# CITY PLANNING COMMISSION

**APPLICATION:** Special Permit to allow a 24 hour convenience store within 500 feet of residentially zoned property.

**LOCATION:** 8461 Folsom Boulevard; Northeast corner Folsom Boulevard and Julliard Drive

**APPLC. NO.** P86-309 **MEETING DATE** November 13, 1986 **ITEM NO.** 12

# EXHIBIT G POLE SIGN

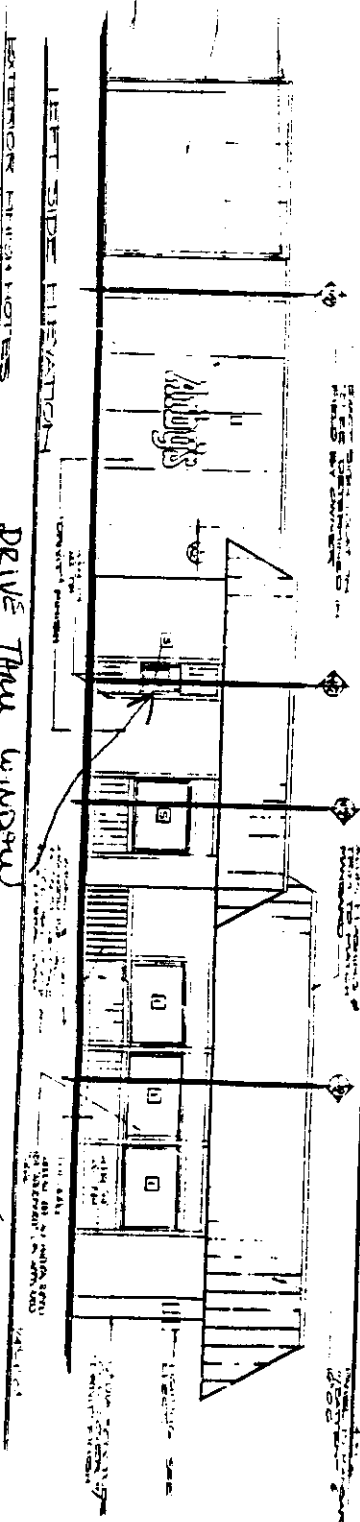
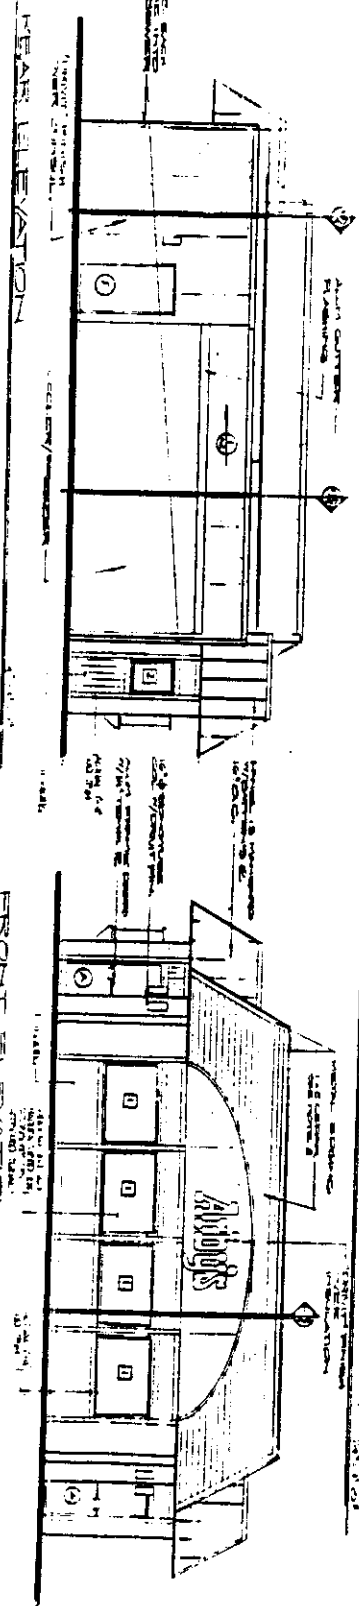
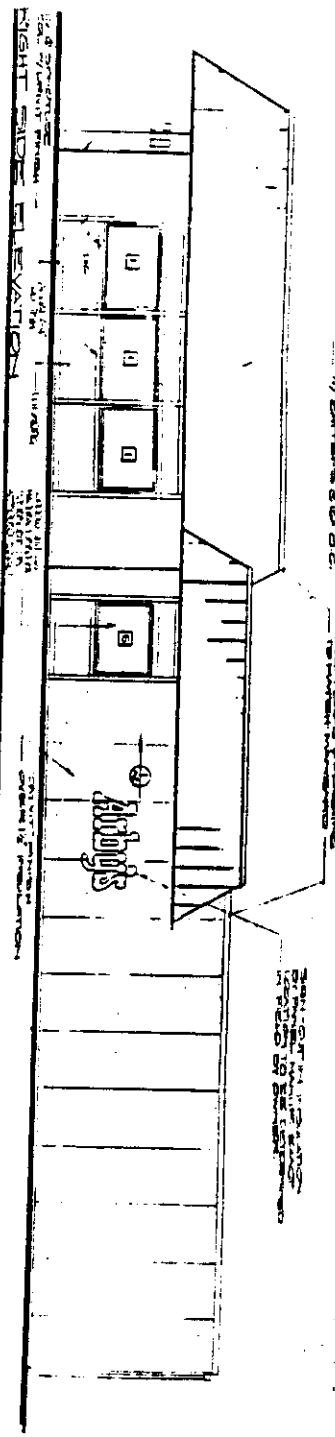
6. A sign program shall be reviewed and approved by the Planning director prior to issuance of sign permits. To reduce visual sign clutter on a major intersection, staff suggests that the proposed double pole sign on the corner be limited to 12 feet in height and redesigned as a monument sign with a masonry base.

4. The applicant shall submit detailed landscape and irrigation plans for review and approval by the Planning Director prior to building permit issuance.
5. Applicant shall submit detailed signage program for review and approval by the Planning Director prior to issuance of sign permits. The proposed corner pole sign shall be redesigned as a monument sign with a masonry base and shall not exceed 12 feet in height.
